Enclosed are two transfer applic from Robert Bybee and the work-up by Jim Rush of Rocky Mt Environmental. When I started to review the Analysis provided I noticed that the conclusion on pg 8 states that there is no negative effect on any reach when you go to the TO well. I questioned Jim on this and he stated that he factored in the 6 acres on the second transfer as a mitigating entity.

HYDROLOGIC ANALYSIS

Rocky Mountain EnvironmentalSM (RMEA) has prepared this Hydrologic Analysis for an application to transfer Right Number 31-11443-A. This license authorizes the irrigation of 33 acres at 0.66 cfs; the consumptive use is 99 acre-ft/year [afa]. The Place of Use [P/U], from which Right Number 31-11443-A will be transferred, will be removed from irrigated agriculture and "dried up."

This chart compares pre-transfer total stream depletion to total stream depletion after transfer to the two new P/D. Depletion in each stream reach for each trimester is summed to produce total stream depletion in the Snake River System.

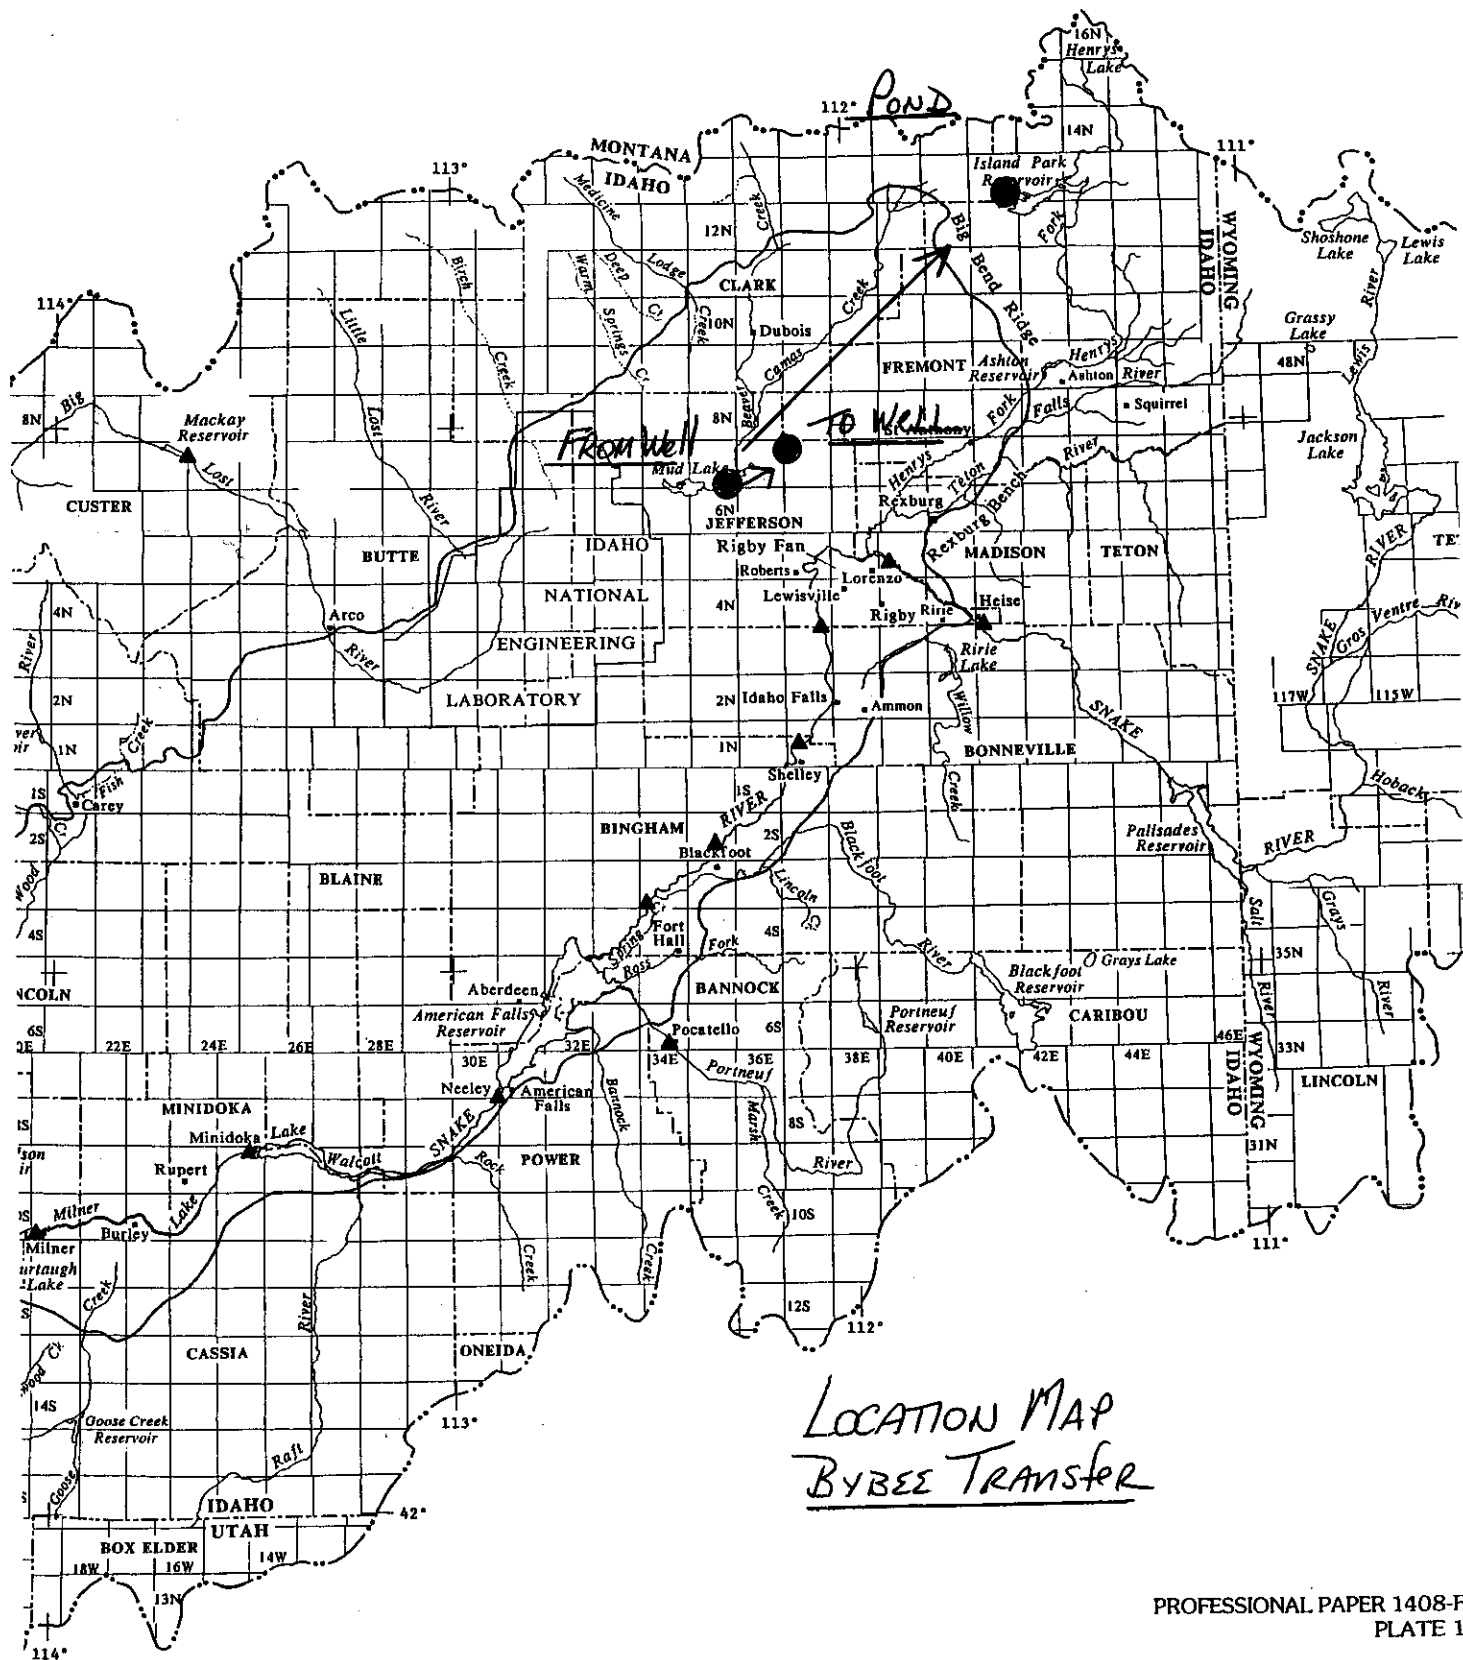
He feels that by taking the 6 acres out of the ESPA for use in a pond of 3.75 surface acres that the 2.25 acres left without irrigation is sufficient. He states that the graph on pg 11 of the Analysis shows that the post transfer depletion is less than the pre-transfer depletion.

I ask that you submit this concept to someone who is a lot better at this than we are in Eastern and determine if Jim Rush's concept can fly. I thank you in advance.
